# SERVICE BULLETIN

**SUBJECT:** PN 369A1800 SERIES AND PN 369H1800 TAIL ROTOR PITCH CONTROL ASSEMBLY - SEATING OF BEARING INNER RACE; TORQUE INCREASE FOR PN 369A1817 LOCKNUT

**MODELS AFFECTED:** All 500 Model 369H Series Helicopters

Figure 1. Tail Rotor Pitch Control Assembly - Seating of Bearing and Increased Torque for Locknut

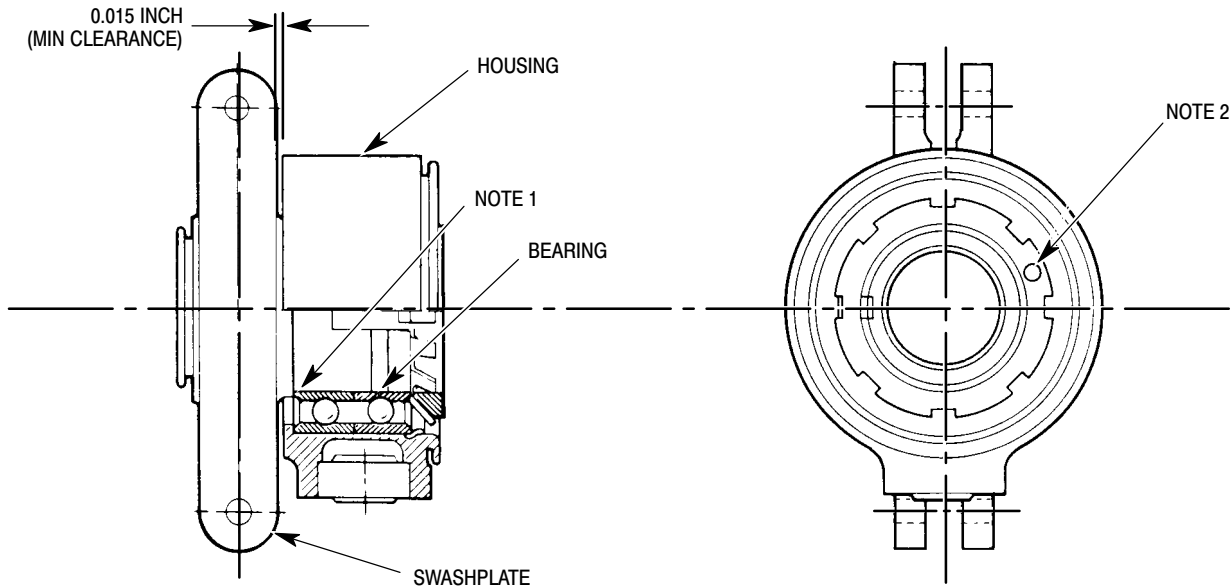
**PREFACE:** The information given in this Service Information Notice lists a procedure for seating the double row ball bearing of the tail rotor pitch control assembly, to ensure that the bearing inner race is firmly in contact with the shoulder of the swashplate. At reassembly of the pitch control assembly, the locknut is torqued to 400 to 450 inch-pounds. Reseating of the bearing inner race and increasing the torque for the locknut is designed to prevent loosening of the locknut and premature wear of the bearing during tail rotor operations.

It is to be noted that PN 369A1800 Series and 369H1800 Pitch Control Assemblies identified with a white dot on the locknut (See Figure 1) are not affected by this Notice.

- d. Place housing and swashplate assembly on arbor press bed with swashplate end down. Apply 2000 pounds of pressure to press inner race of bearing firmly in contact with shoulder of swashplate. Use suitable tube or sleeve to press INNER race of bearing only. Remove assembly from arbor press.

- e. Install new 369A1816 tang washer; reinstall locknut and torque locknut to 400 to 450 inch-pounds. Use wrench adapter and torque wrench while assembly is held in holding block, to tighten locknut.

- f. Check for sufficient clearance (0.015 inch minimum) between swashplate and housing (see Figure 1 ).
- g. Check for smooth easy and free rotation without binding.

- h. Bend a tang of the tang washer into bottom of any aligned slot on locknut.
- i. Paint a 0.12 to 0.18 inch white dot on locknut, as shown in Figure 1, to denote reseating of bearing and locknut torqued to 400 to 450 inch-pounds.

- 1. INNER RACE FIRMLY SEATED AGAINST SHOULDER OF SWASHPLATE
- 2. AFTER TORQUE, COLOR CODE WITH WHITE DOT (0.12 - 0.18 IN. DIA.)
